SRNL-STI-2019-00722, Revision 1

**E-AREA LLWF FINAL CLOSURE CAP DESIGN – CONSTRUCTABILITY
EVALUATION CRITERIA FOR THE PLOT 8 AND NR07E DISPOSAL AREAS**

Revision 1: Results of engineering constructability evaluation are shown below.

Figure 3. Annotated Drawing of Plot 8 ETs showing a possible Final Closure Cap Orientation (C-CDL-E-00001, 2010).

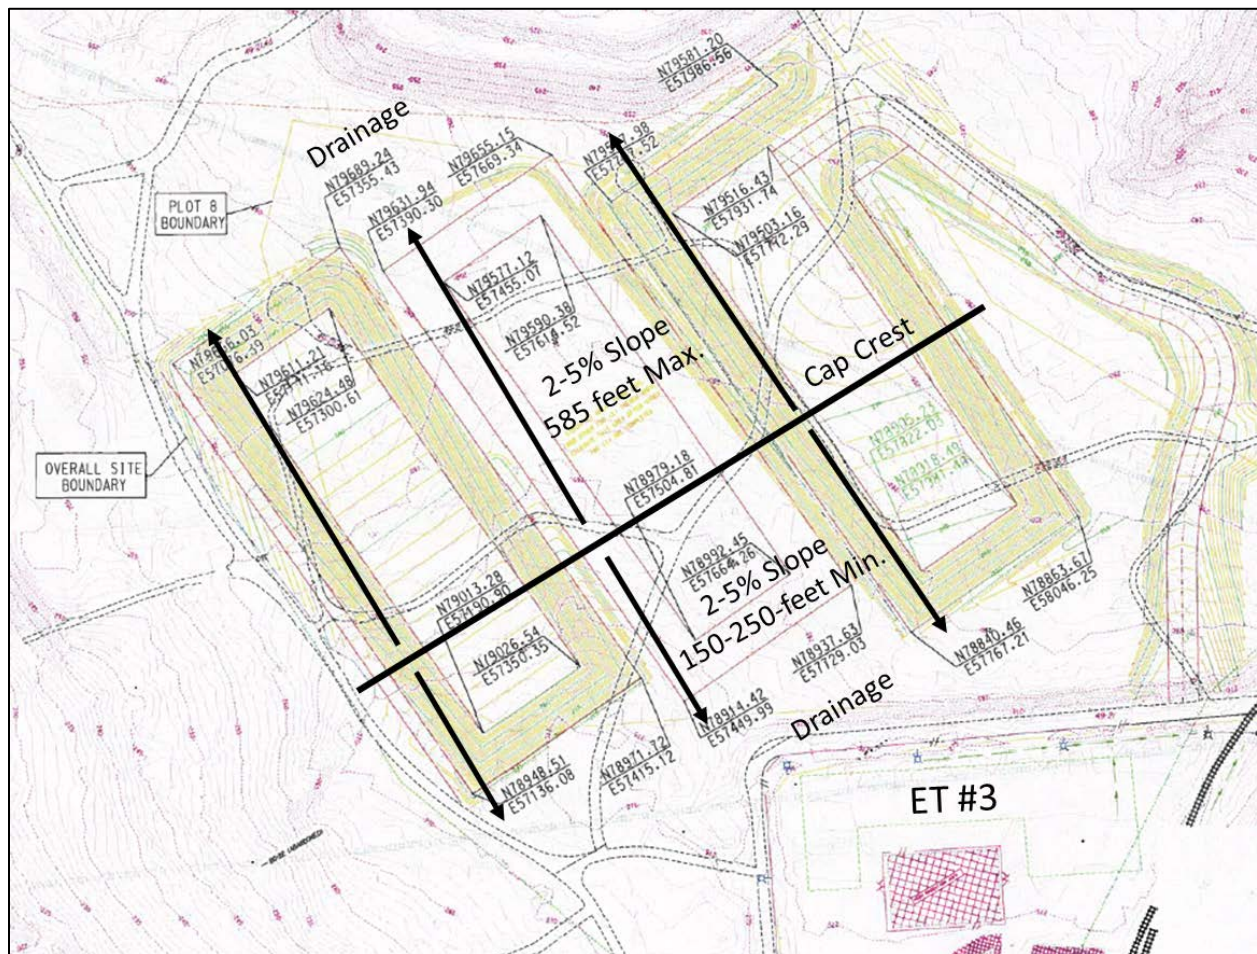
After performing an engineering constructability evaluation, we have found that the closure cap criteria proposed in the memo (SRNL-STI-2019-00722) can be constructed as envisioned.

These additional areas (Plot 8 & 643-7E NRCDA) may be developed as separate caps from the E-Area LLWF conceptual closure cap generated in 2016. However, it would be worth revisiting the possibility of revising the E-Area LLWF conceptual closure cap to include Plot 8 within the limits of the overall cap.

- The preferred closure cap orientation is for the crest of the cap to run perpendicular to the longitudinal axis of the ETs such that surface run-off and drainage occur to the north and south sides of the disposal units as shown in Figure 3. ET03 is located to the south of Plot 8. The North-South positioning of the closure cap crest in Figure 3 is just one possible location.

Figure 11. Final Closure Cap Crest and Slope Concept for NR07E.

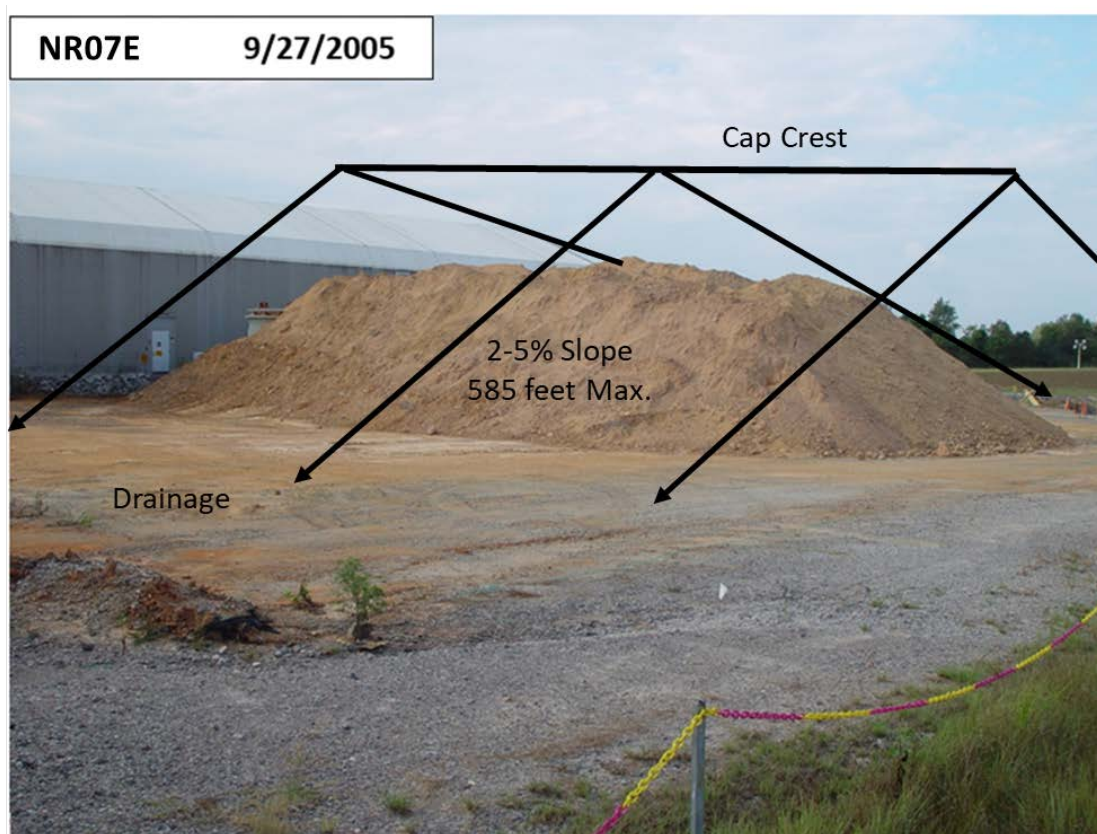
- The preferred closure cap orientation is for the crest of the cap to run parallel to the longitudinal axis of the current interim soil cover such that surface run-off and drainage occur to the east and west sides of the disposal unit as shown in Figure 11.
